MEMO TO: Prospective Bidders
FROM: Kimberly Toon, Purchasing Manager
SUBJECT: **Addendum #1:** ITB – Mazarick Park Tennis Center Tennis Sitework
DUE DATE AND TIME: **October 31, 2024; 2:00 p.m.**

1. The Bid Documents are hereby modified per the attached Addendum #1 dated October 28, 2024. To include the following:

**Mazarick Park
 Tennis Center**
 730 Filter Plant Road
 Fayetteville, North Carolina

5 Electrical Cover Sheet E1.0

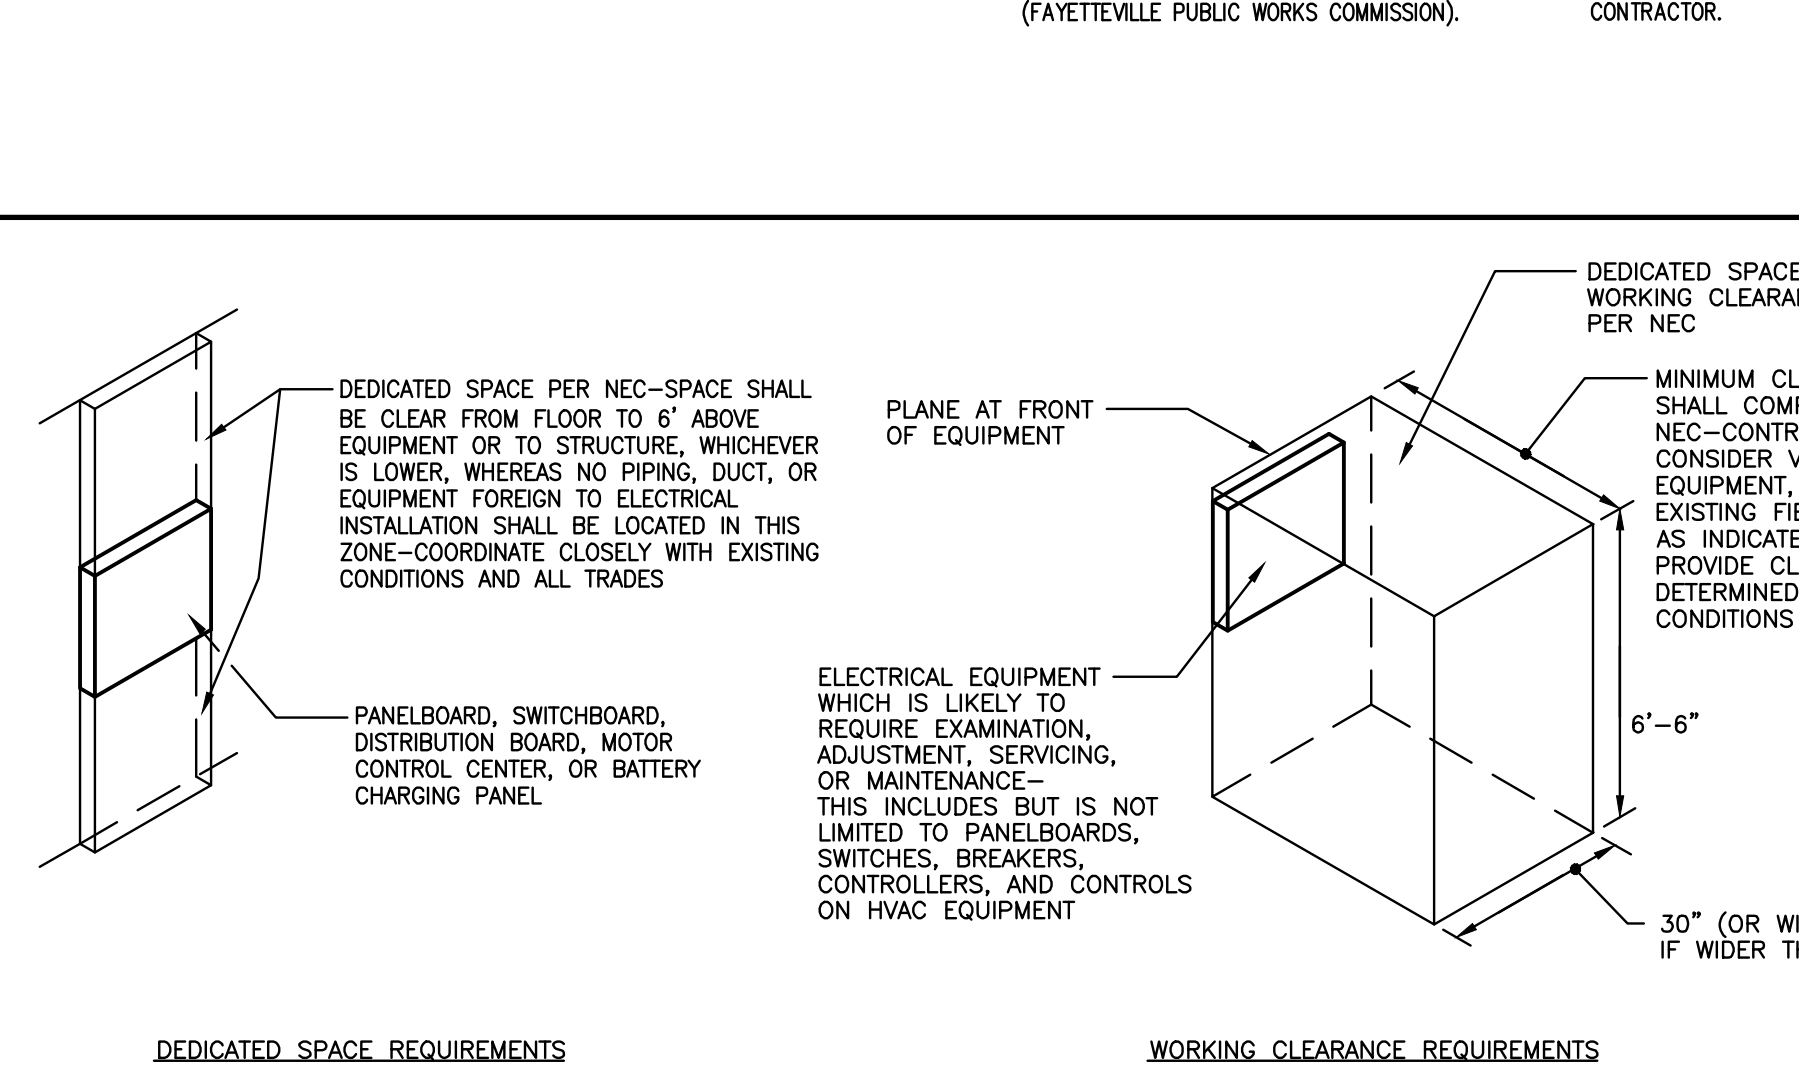
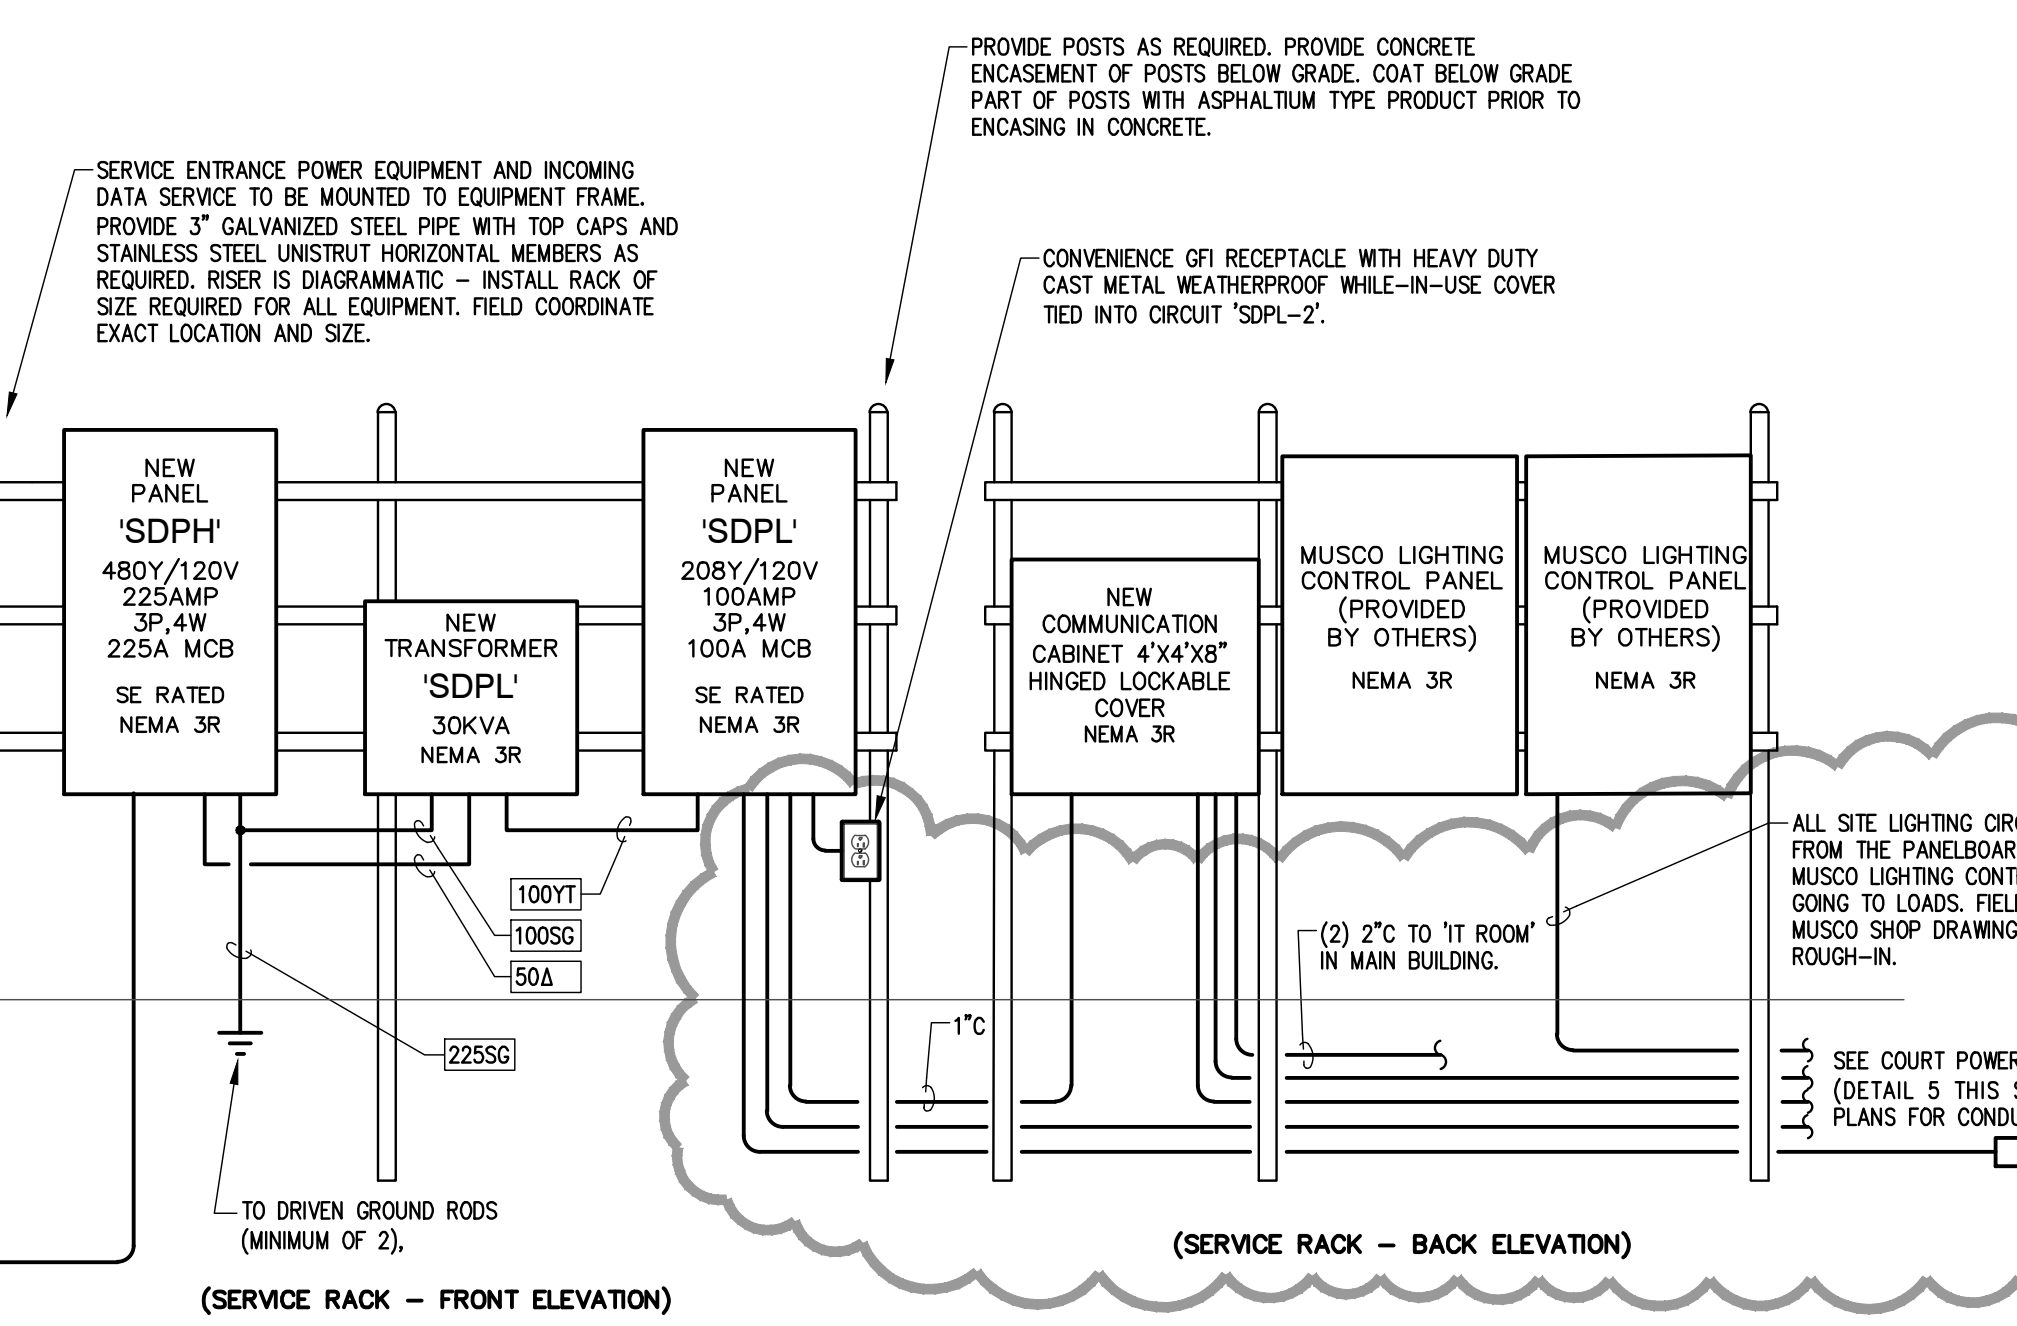
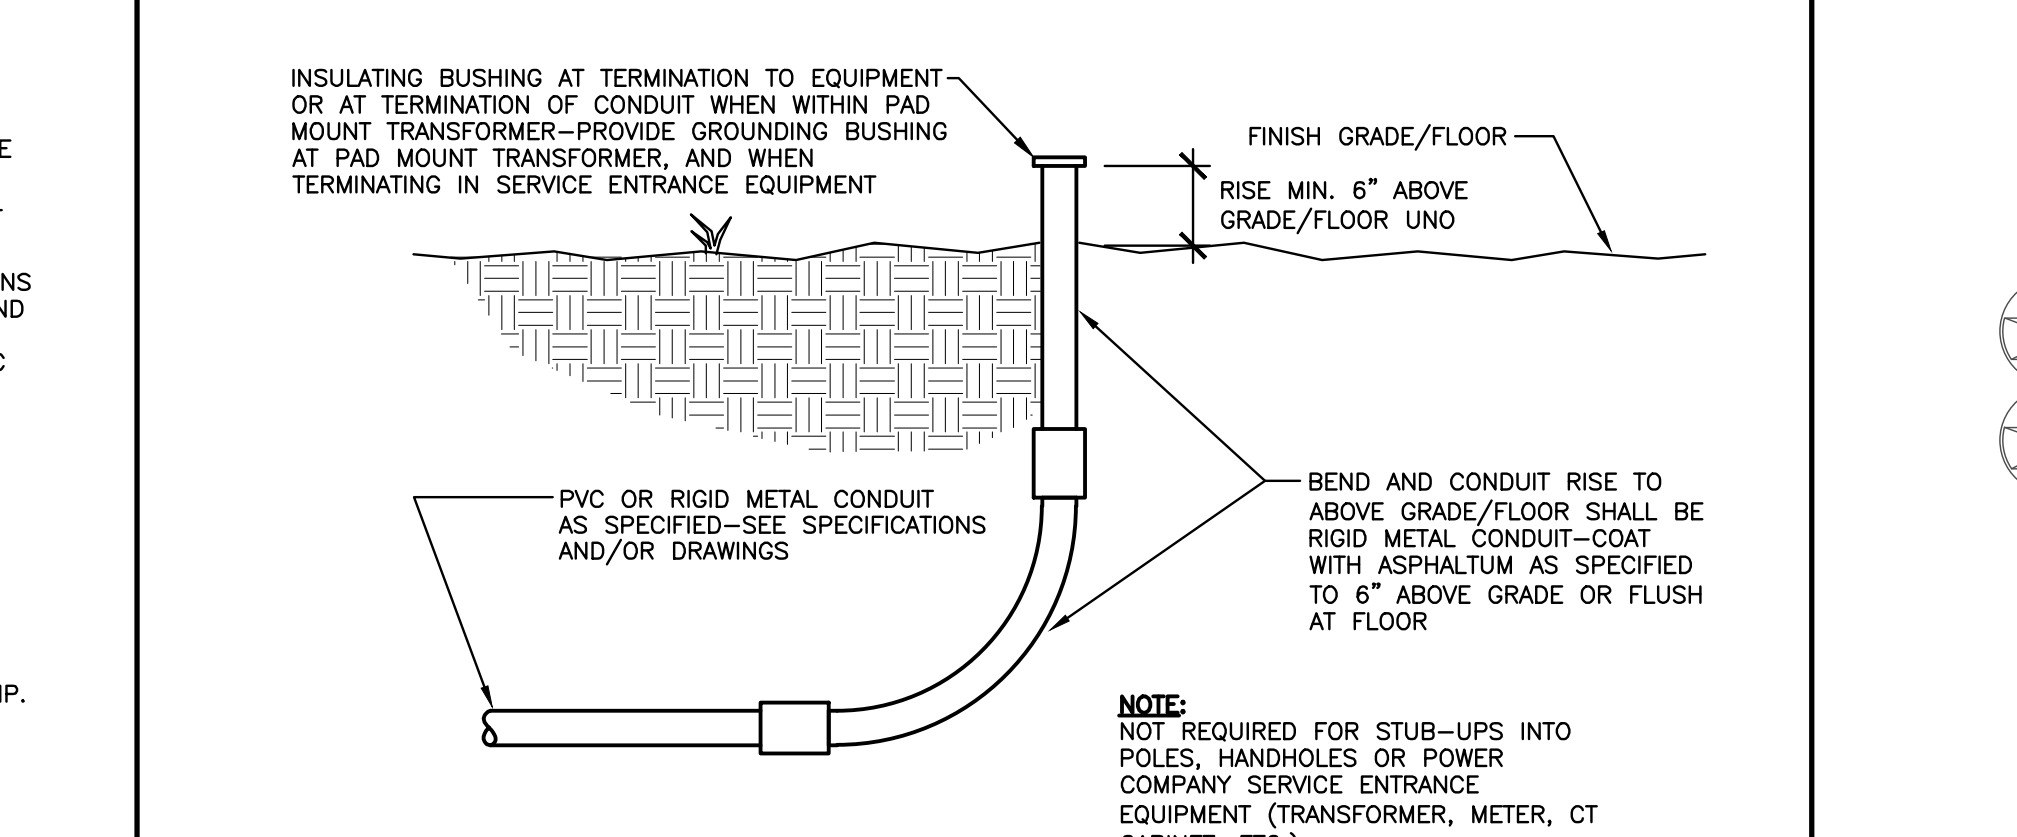
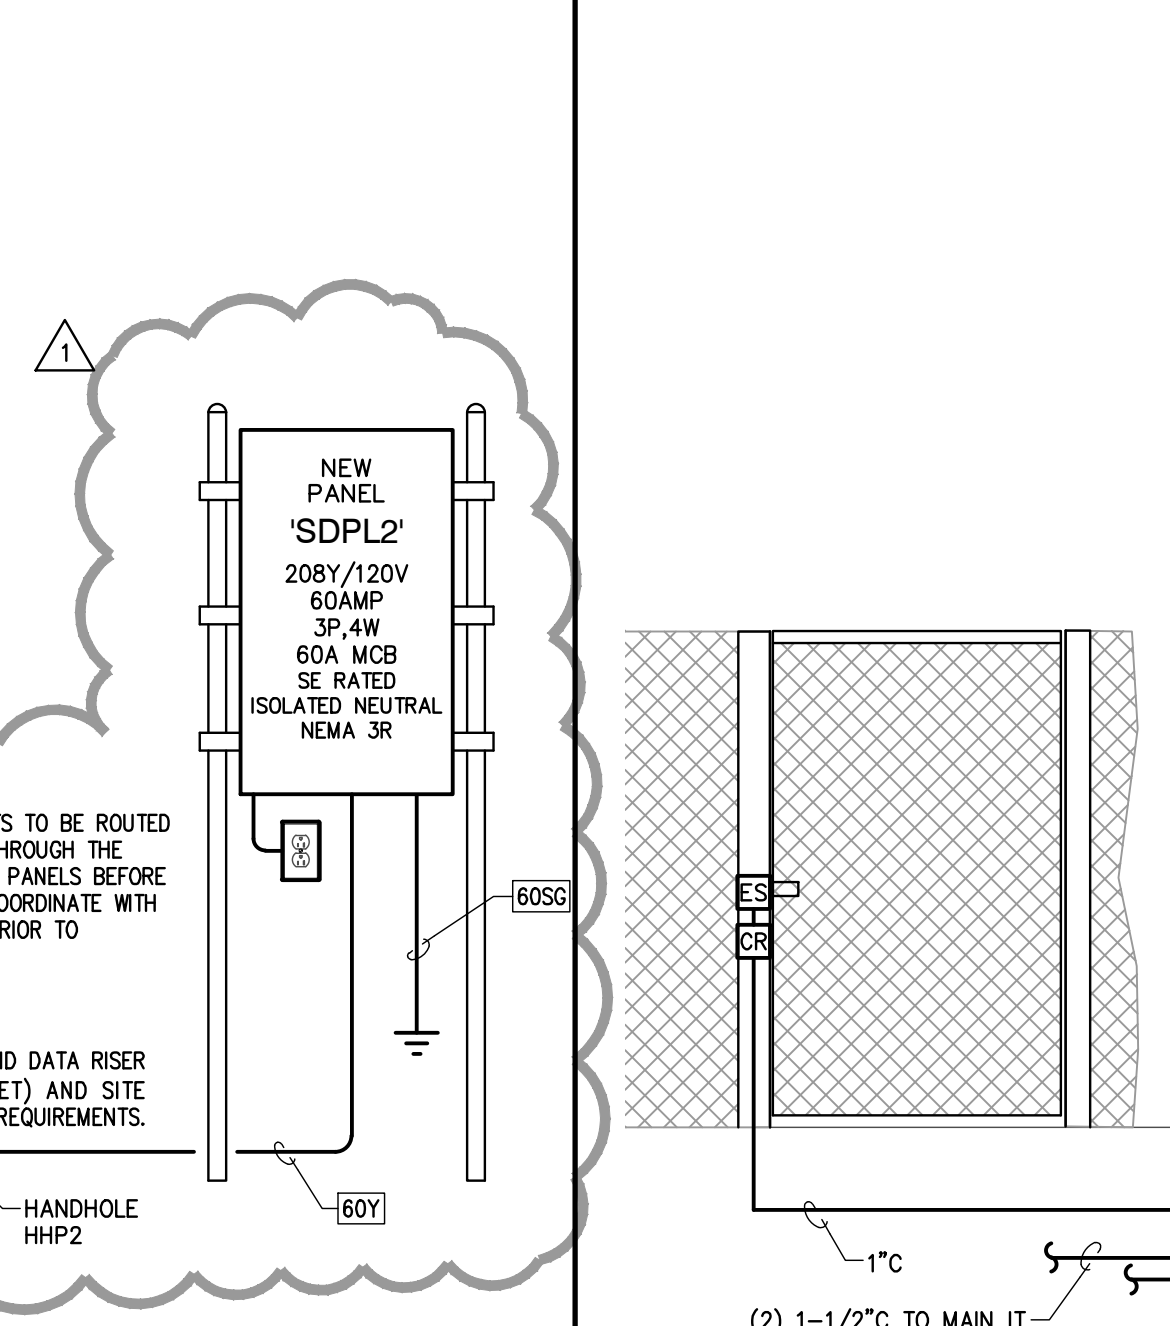
Question: Could you provide drawings: E1, E2, E3?

Answer: The electrical sheets E1.0, E2.0 and E3.0 are attached to addendum 1.
